Memo

Development Assessment

Subject: DA2024/0492 – 49 Blackbutts Road, Frenches Forest

Record Number: 2025/138487

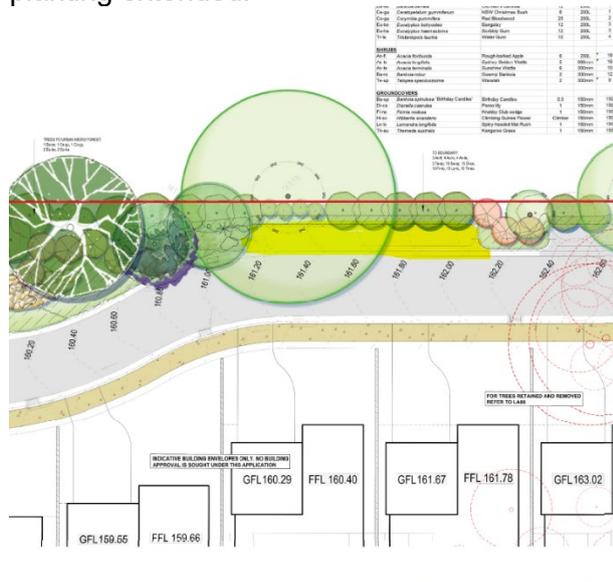
- i) *the retaining walling along the along the eastern boundaries of lots 5 to 13 inclusive shall be relocated to provide an unobstructed landscape planting zone (a minimum of 2m wide). The stormwater pits and drainage lines shall be relocated accordingly.*
- ii) *The three on-street car parking spaces to the south (highlighted in yellow below) are to be deleted and replaced with landscaping with proposed*

planting extended.
